April 20, 2012

**Re: A.12-01-012 – Santa Cruz 115 kV Reinforcement Project  
PG&E's Response to First Set of Data Requests**

## **REVISED ROB ROY SUBSTATION LAYOUT DRAWING**

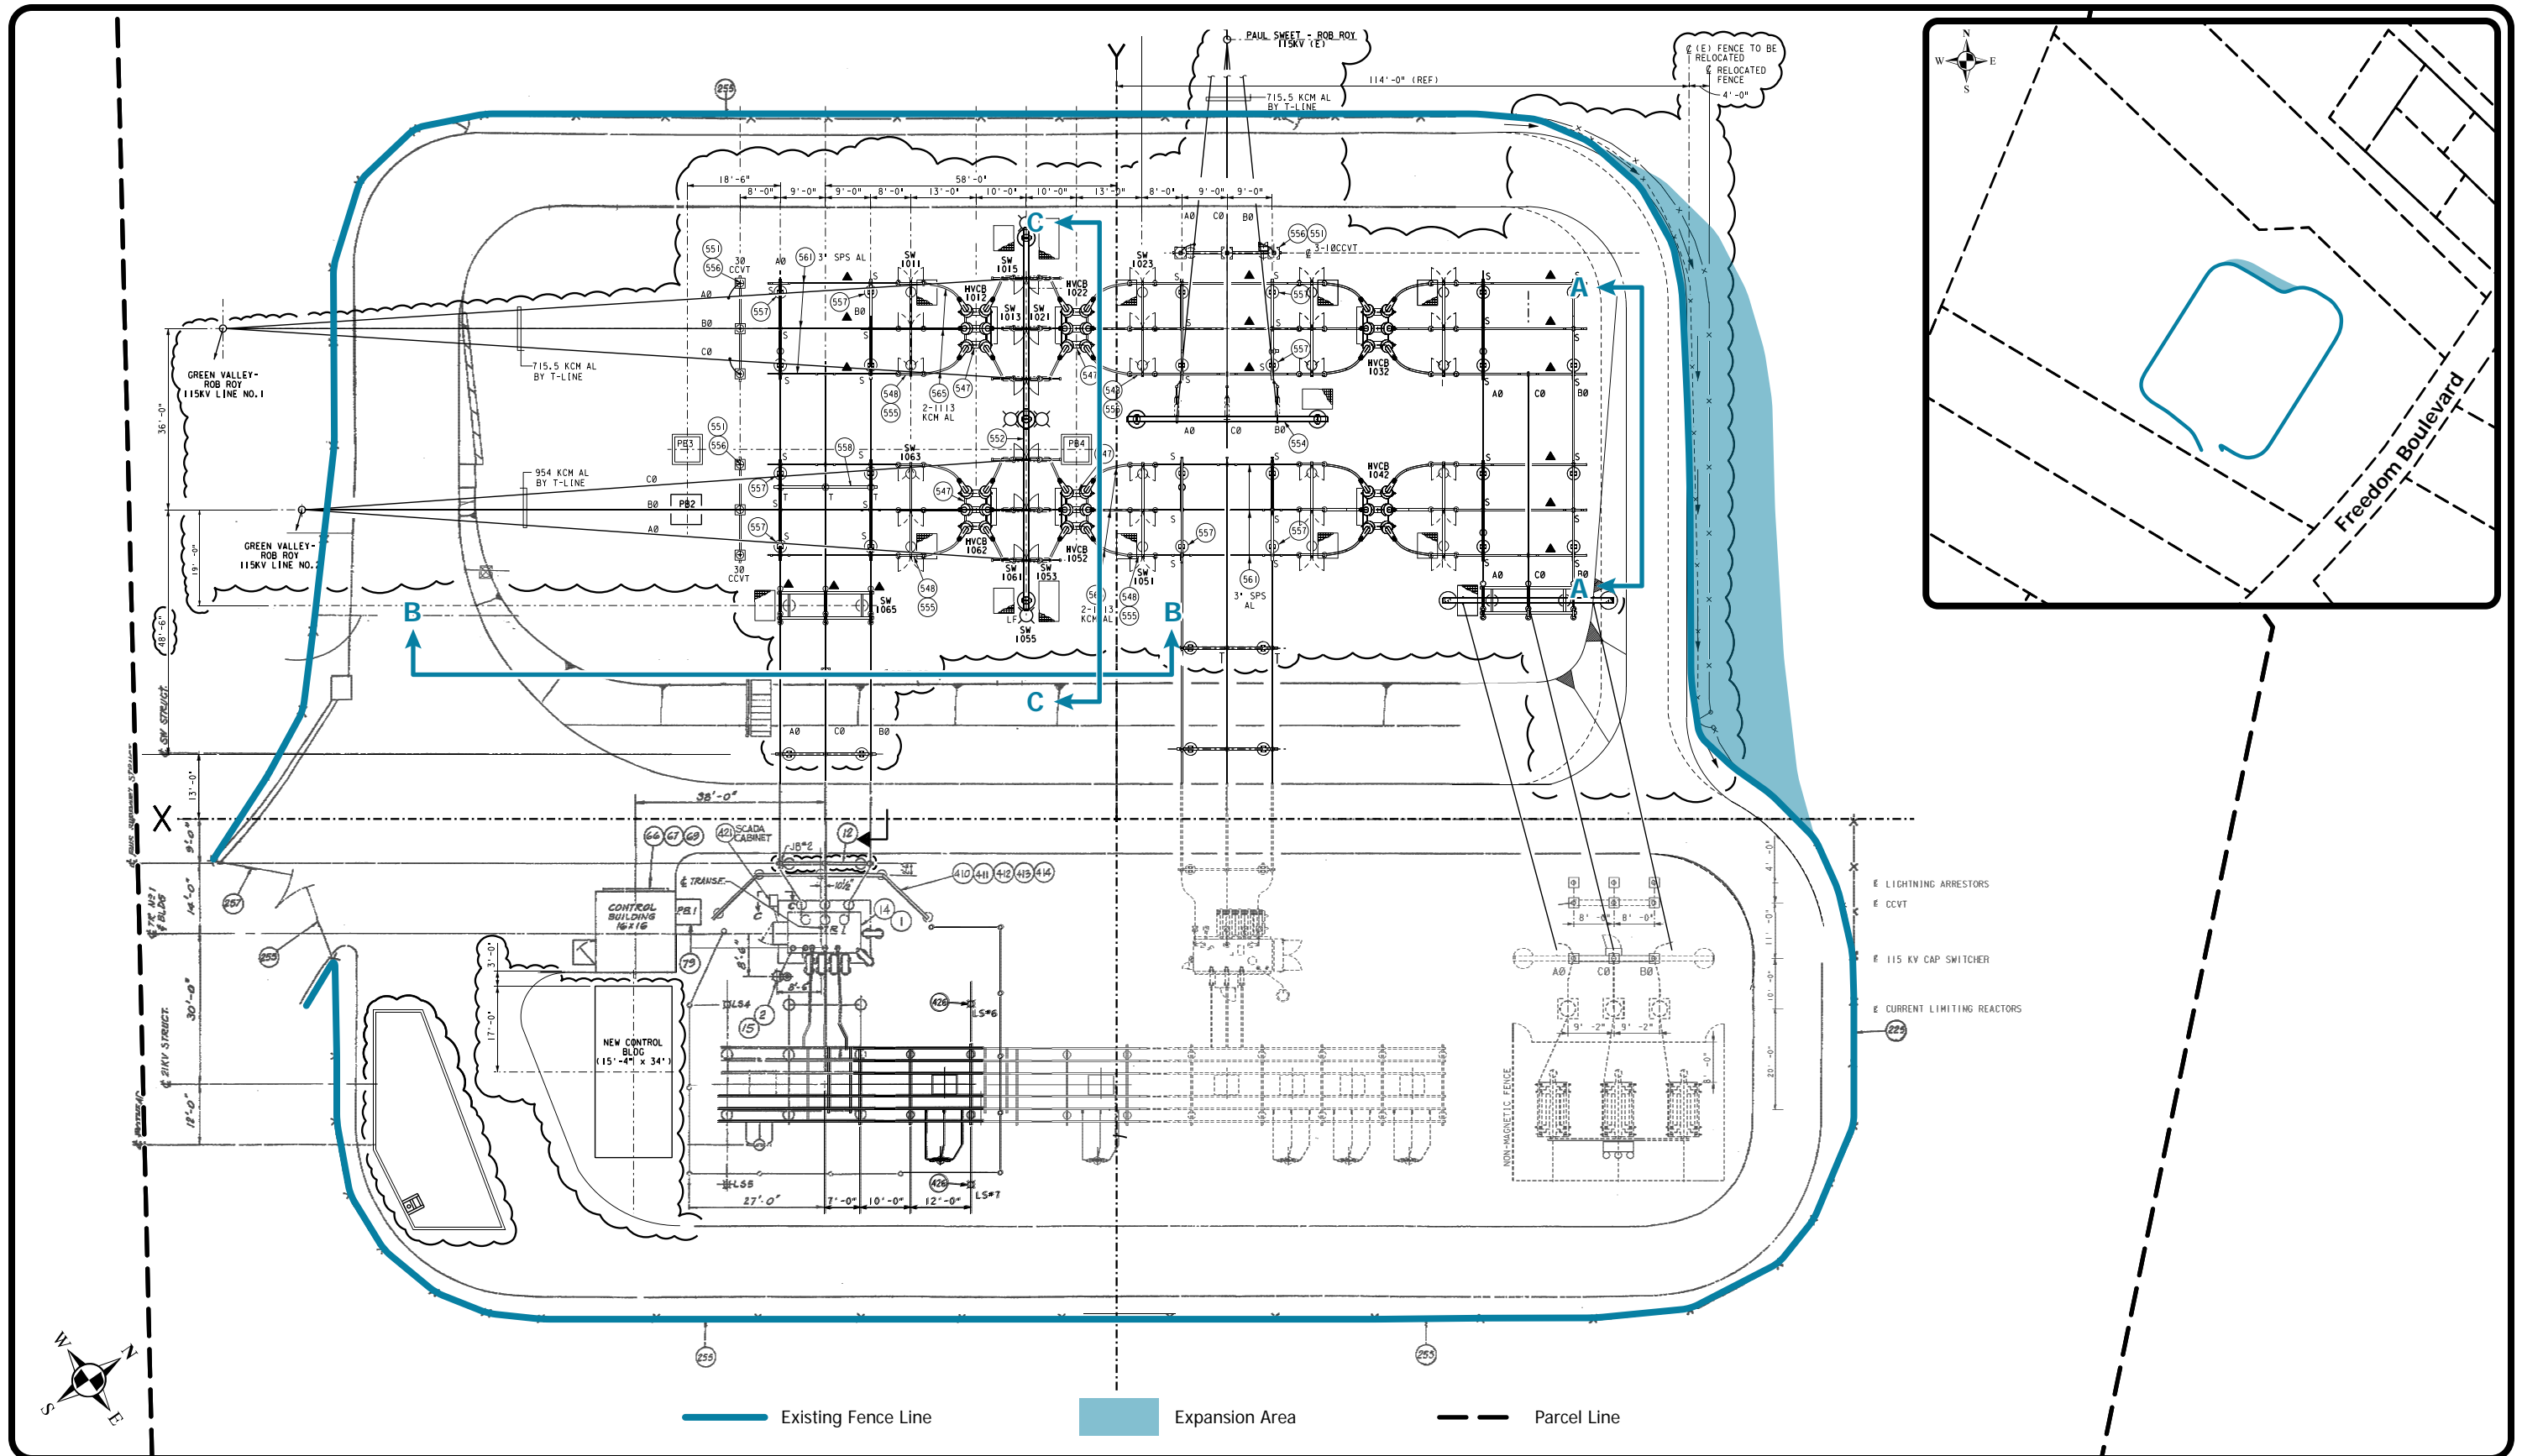
*Section 2.1.3, page 2-2. Provide a figure showing the PG&E substation property lines. The property lines can be added to Figure 2-6. Figure 2-6 should also be revised to be legible.*

A revised version of Figure 2-6: Rob Roy Substation Layout Drawing has been included as **Error! Reference source not found..**

## **CROSSING STRUCTURE TYPICAL DRAWING**

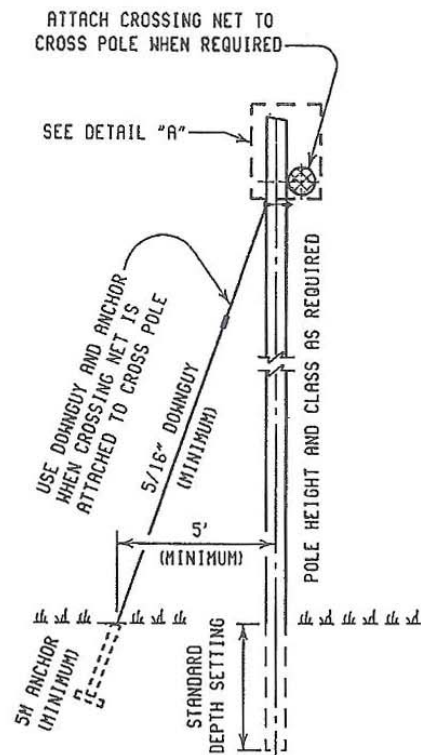
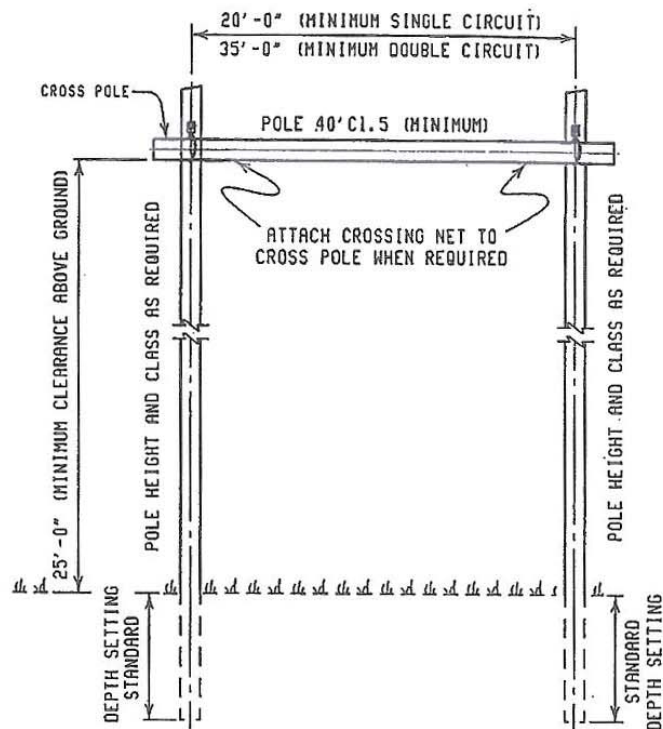
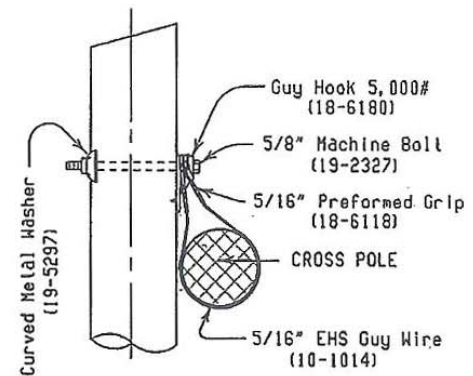
*Section 2.7.8, page 2-31. Please provide a graphic showing a crossing structure.*

Attachment F: Crossing Structure Typical Drawing depicts a typical crossing structure.
